**ADDENDUM NO. 2**

March 18, 2016

**ADDITIONS AND REMODELING TO  
ROBERT ASP, ELLEN HOPKINS AND S.G. REINERTSEN ELEMENTARY SCHOOLS  
MOORHEAD AREA PUBLIC SCHOOL DISTRICT 152  
MOORHEAD, MINNESOTA**

ADD2.1 - Detail through canopy edge

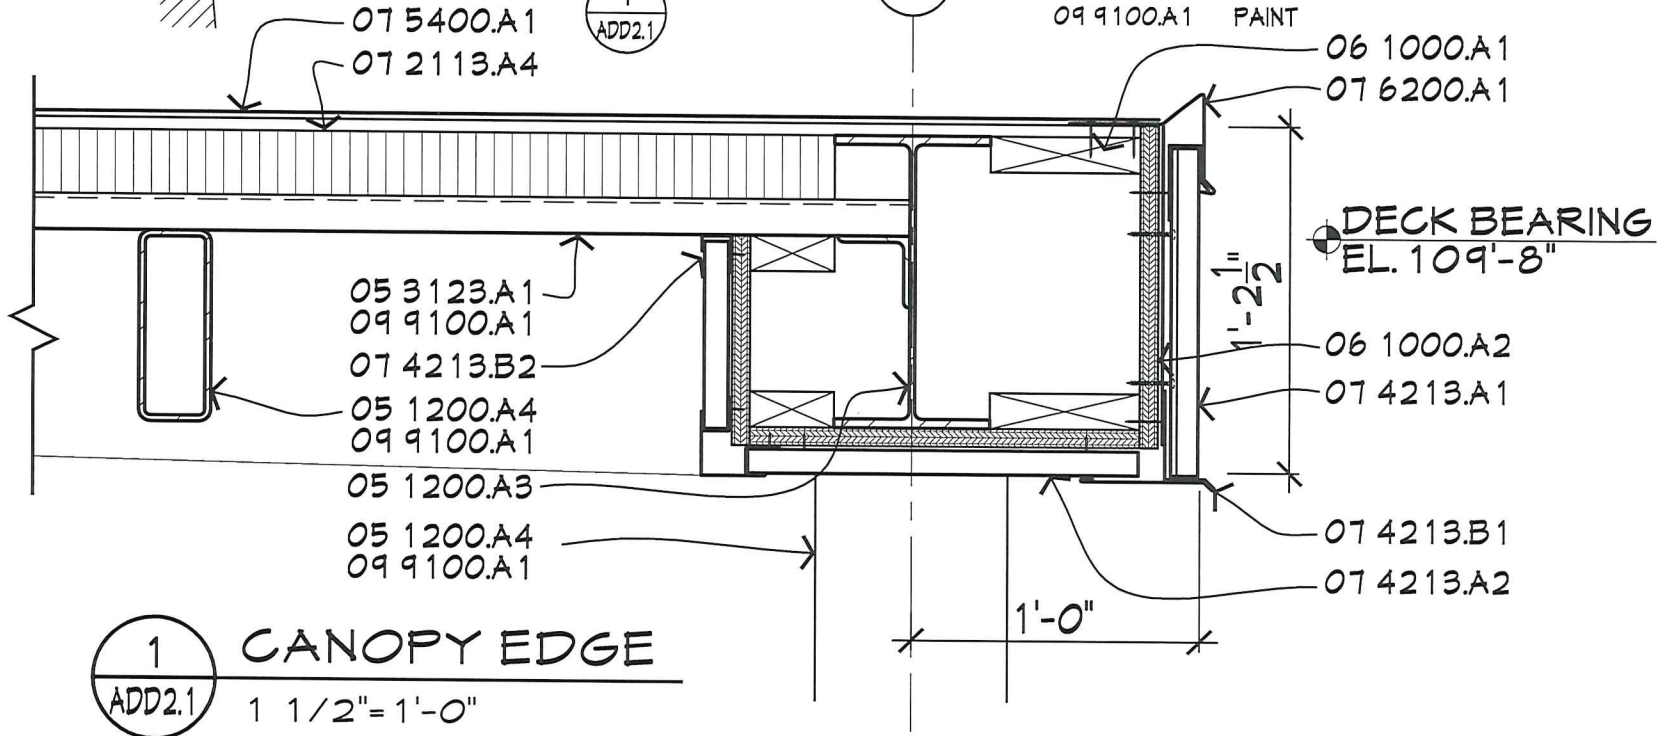
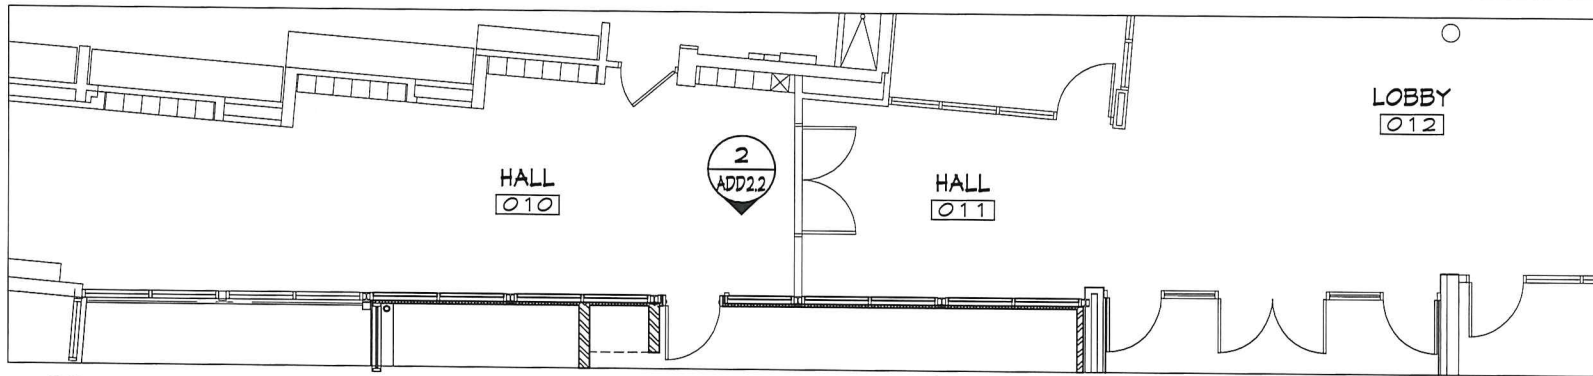
1. Section 3/A3.1 - Section through canopy
  - a. See attached ADD2.1 which better illustrates a detail through the canopy edge.

Sheet No.  
**ADD2.2**

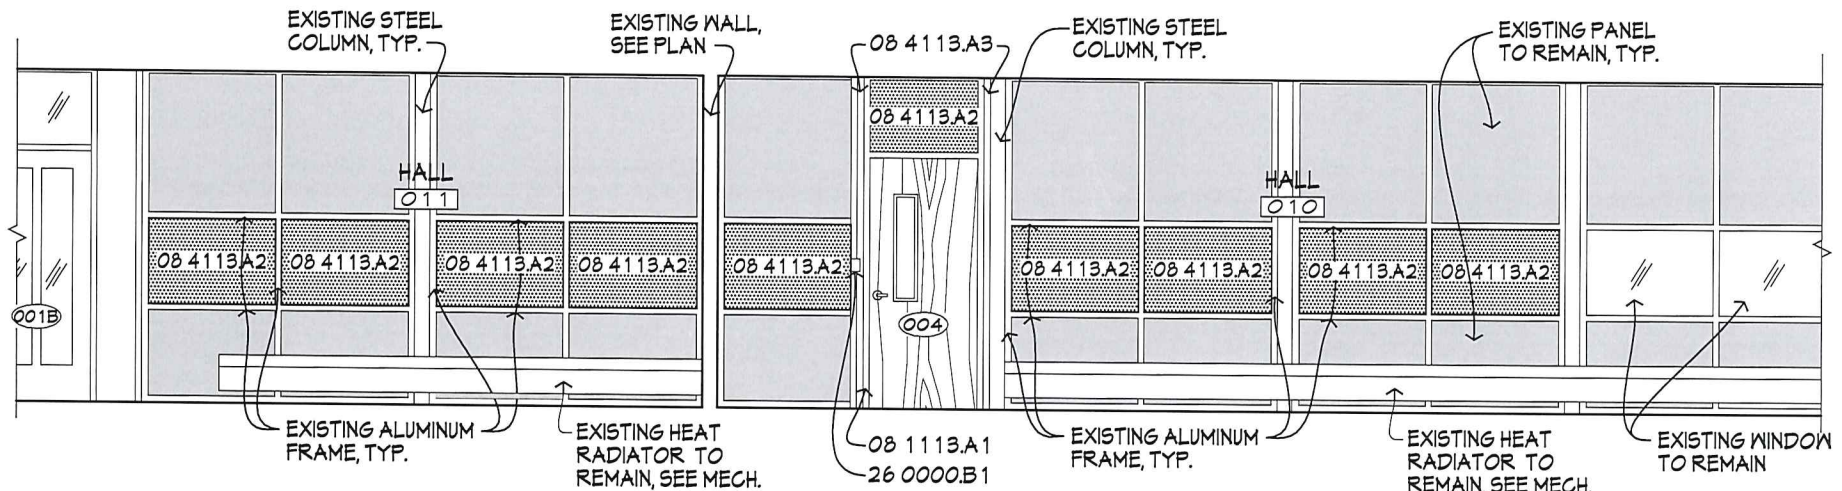
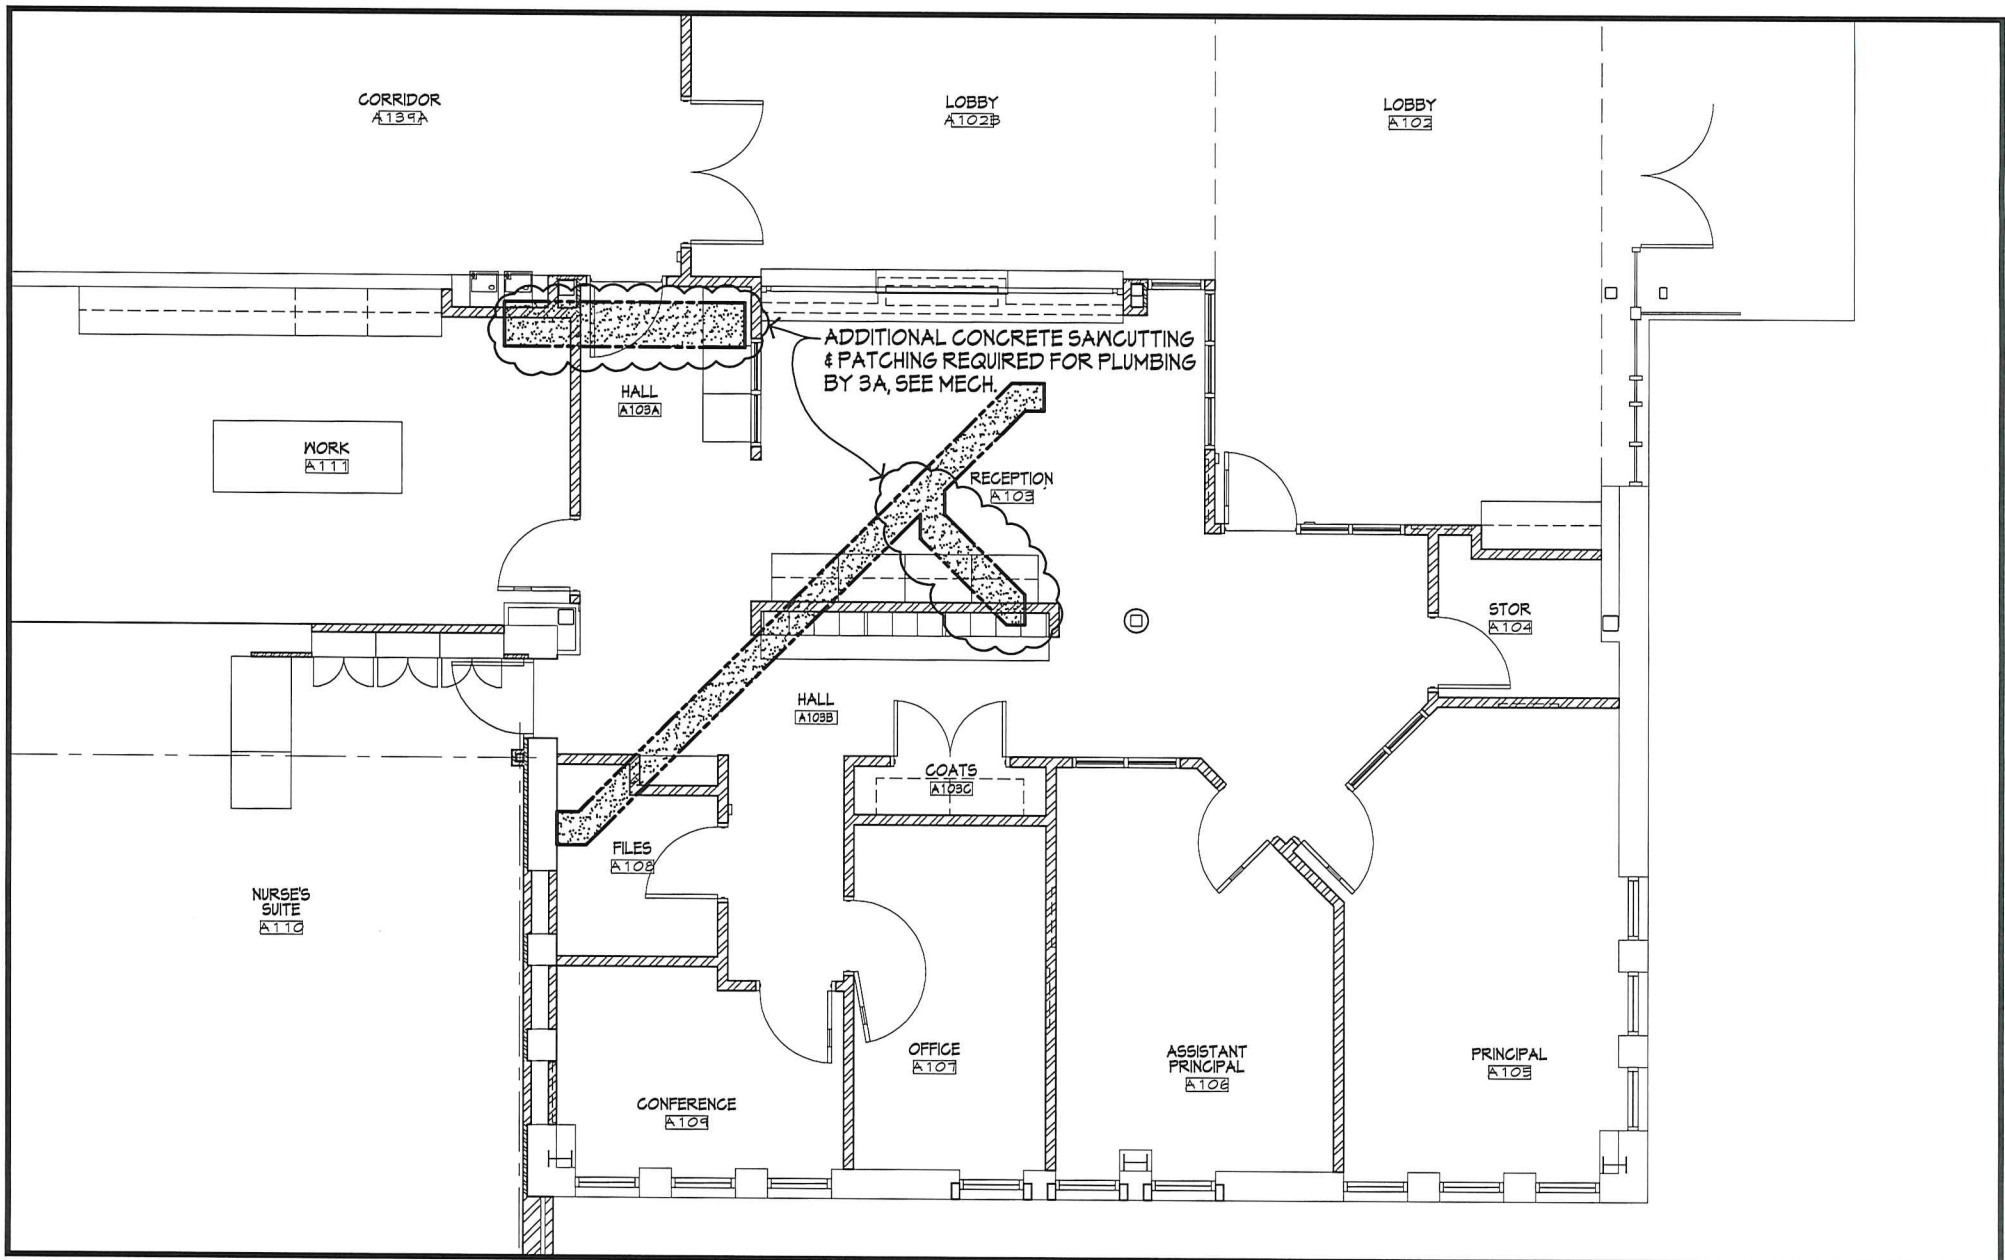
1. Hall 010 and Hall 011:
  - a. Existing aluminum frame and insulated panels to remain at south wall.
  - b. See attached drawing ADD2.2 which illustrates the installation of new insulated aluminum faced panels (Mapes or similar) in existing aluminum frames.

Sheet No.  
ADD 2.3

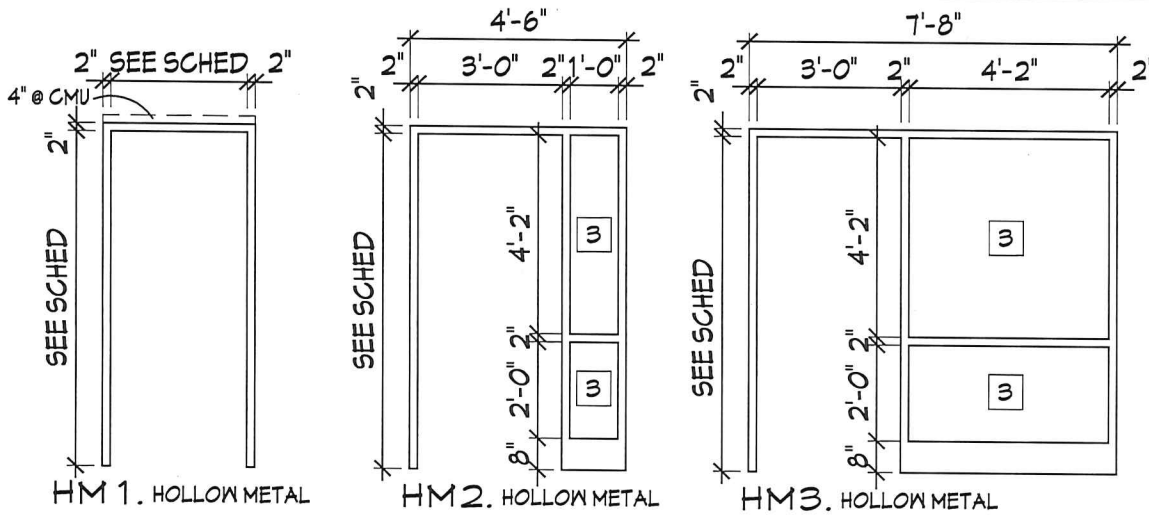
1. Demolition Note 15
  - a. Ceiling tiles to be removed and salvaged by Bid package 6A and reinstalled by 9E.
  - b. See ADD2.3 for additional floor saw cutting and removal work.
2. At existing Conference Room 4 east wall
  - a. Remove and salvage existing marker board and give to owner.

1. At all new base cabinet and upper cabinets - provide blocking in walls to secure cabinets. Blocking need not be Fire rated.
  - b. Two sides of SE bump out at Work A111.
  - c. Two sides of SW bump out at Conference A109.
  - d. South wall of Assist. Principal A106
  - e. South wall of Office A107
  - f. East wall of Storage 104.
3. At walls that contain openings A102A, A139 A&B, A142 and A139 D&C: these new walls are to be constructed up against existing walls. Provide USG - 200A casings at new walls in lieu of corner beads so that existing walls do not need to be taped, sanded and painted when corner beads are used.
4. See ADD2.3 for additional concrete floor patching.

ADD 2.4

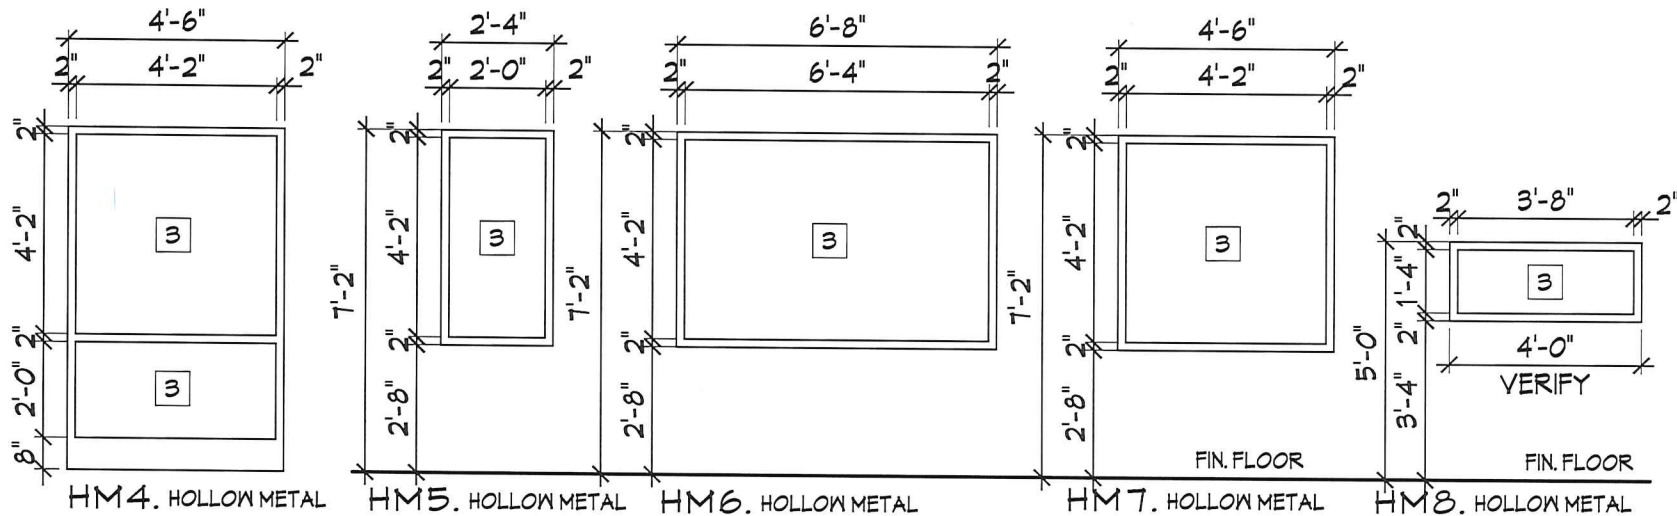
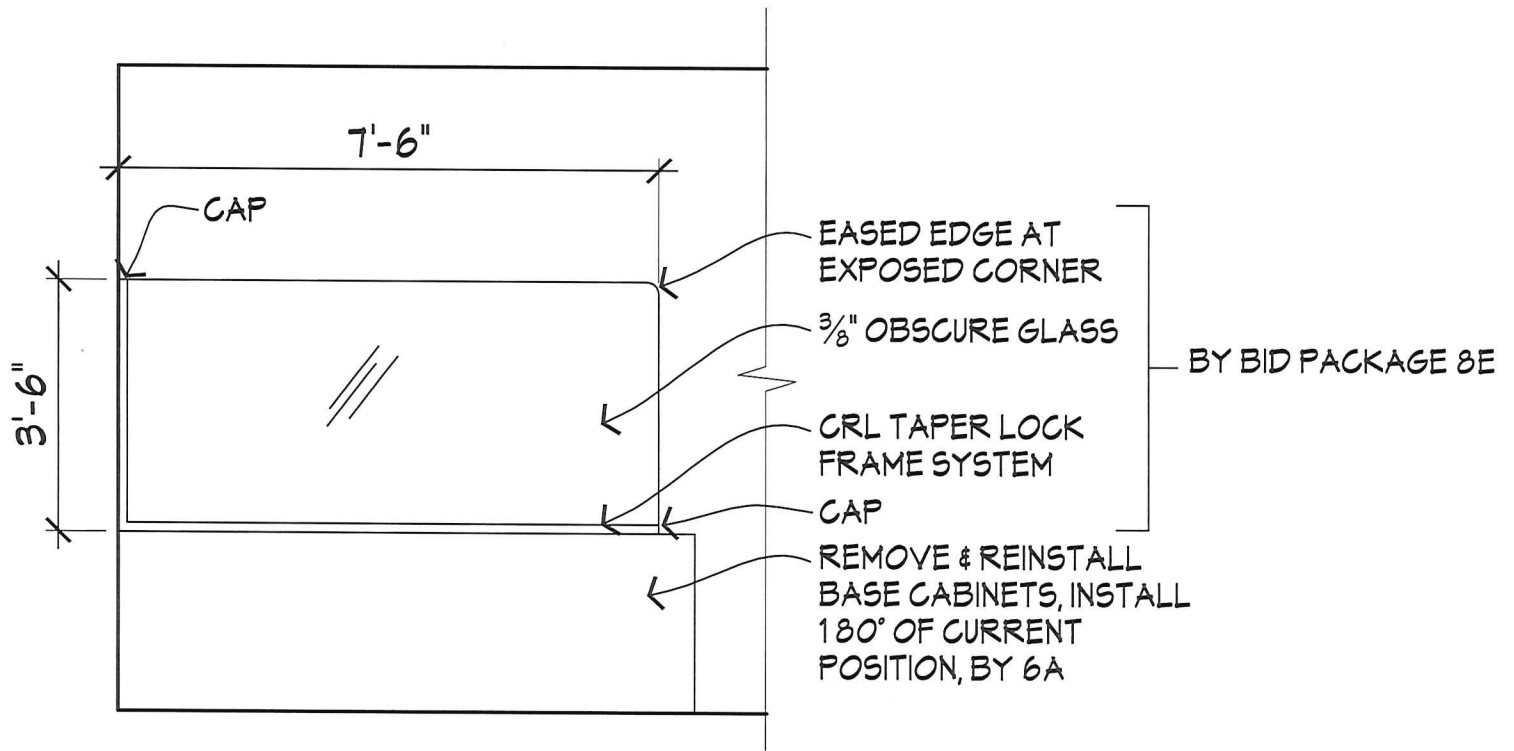
1. See ADD2.2 for revised HM frame elevations.
2. A1 1 frame elevation: Note below title is listed as '08 4413. A1' but should read as '08 4113.A1.'
3. Door and Frame Schedule:
  - a. Door opening A 102 - Change frame type from 'Ex' to 'HM 3'.
  - b. Door opening A 105 - Change frame type from 'Ex' to 'HM 3'.
  - c. Door opening A 110A - Change frame type from 'Ex' to 'HM 2'.
4. Room Finish Schedule
  - a. Add A103C to include carpet tile, rubber base, all walls to be painted and acoustical lay-in ceiling.
5. Room finish notes
  - a. Add Note 5 to install salvaged carpet tiles in lieu of new. This note should apply to the following rooms:
    - Conference Room A102A
    - Coats A103C
    - Storage A104
    - Files A108
    - Conference109

9 WORK A 1 1 1  
 A4.1 3/8"=1'-0"

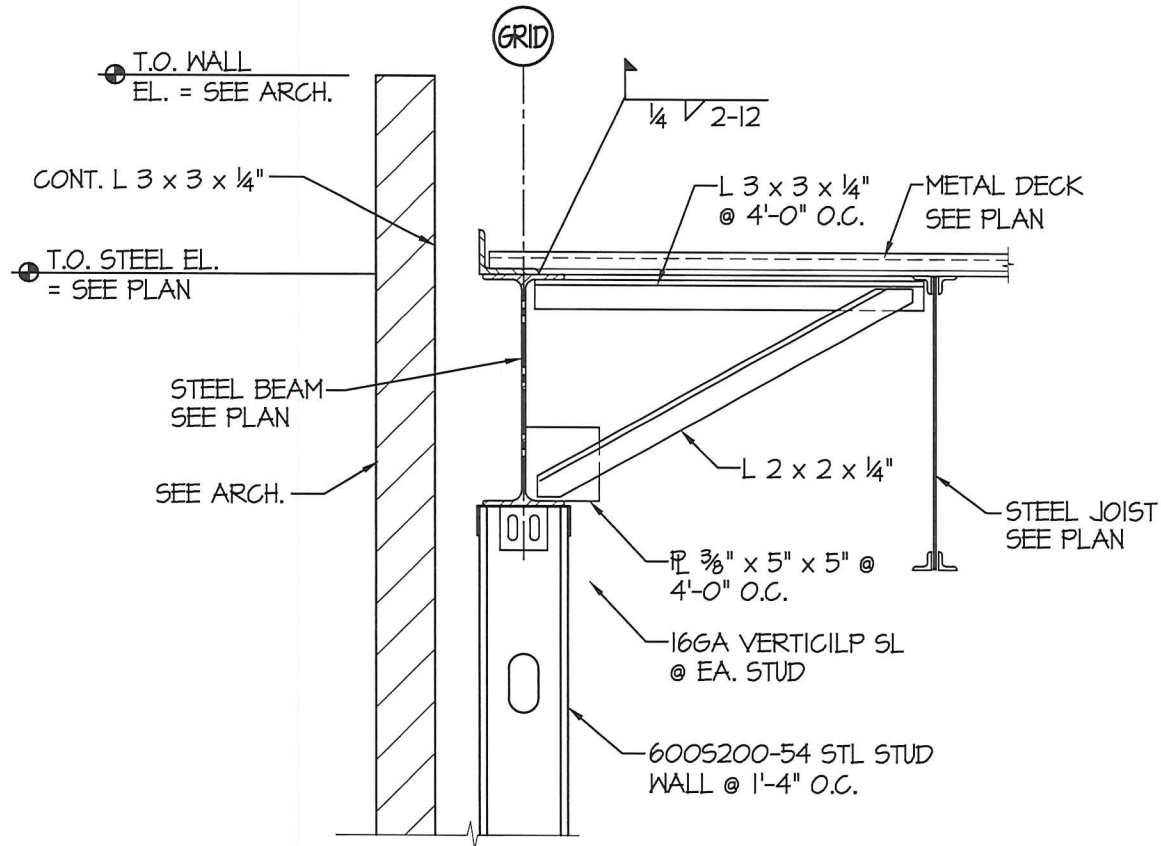
1. Change detail to that shown on attached sheet ADD2.5.

7 DECK BRG DETAIL  
 S4.1 1" = 1'-0"

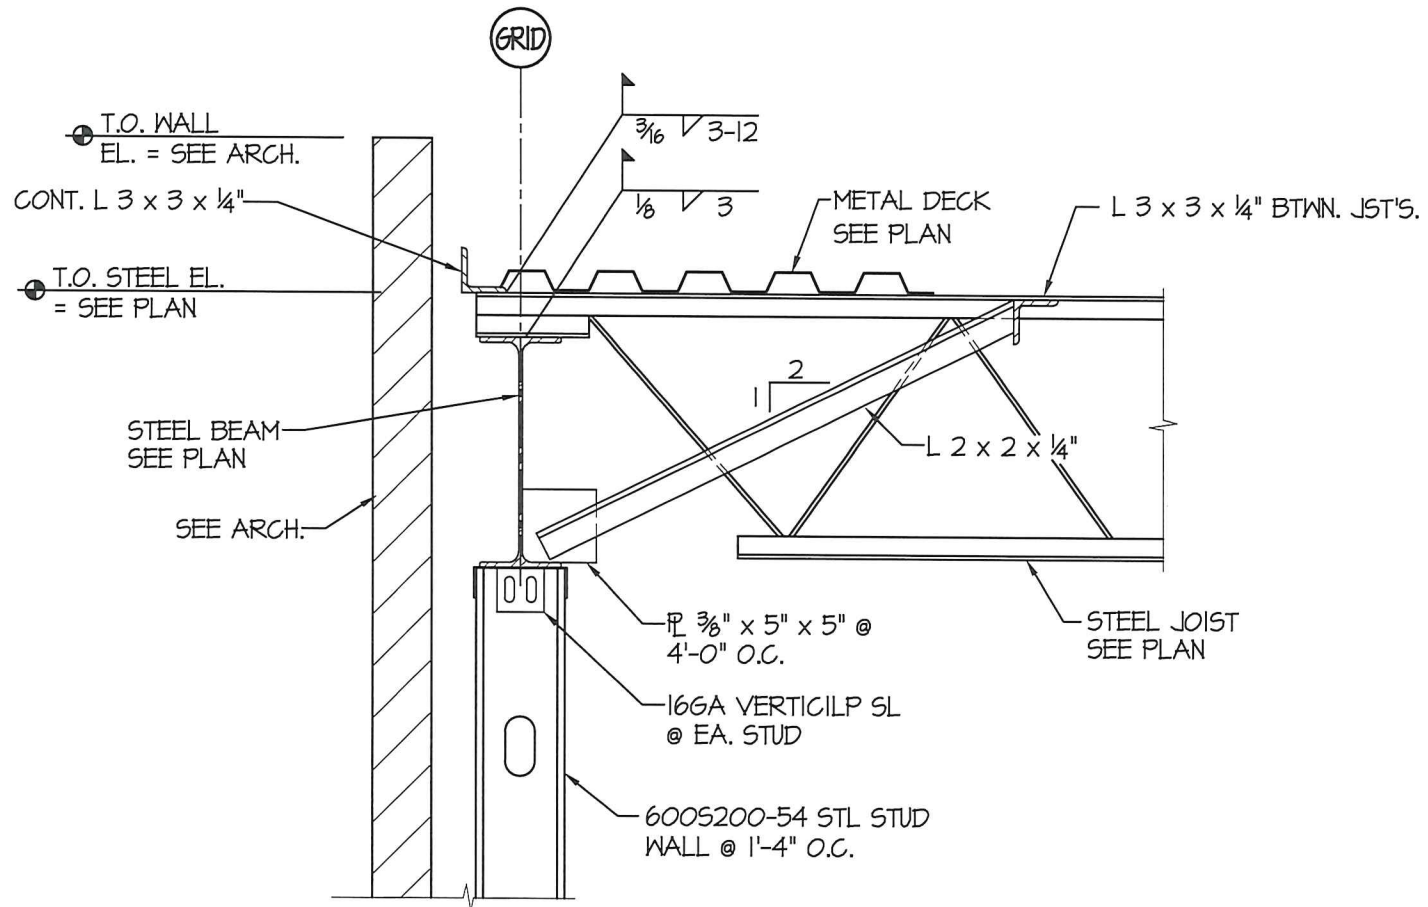
1. Details S4.1 Toilet A110B:
  - a. See attached revised details 7/S4.1 and 8/S4.1.
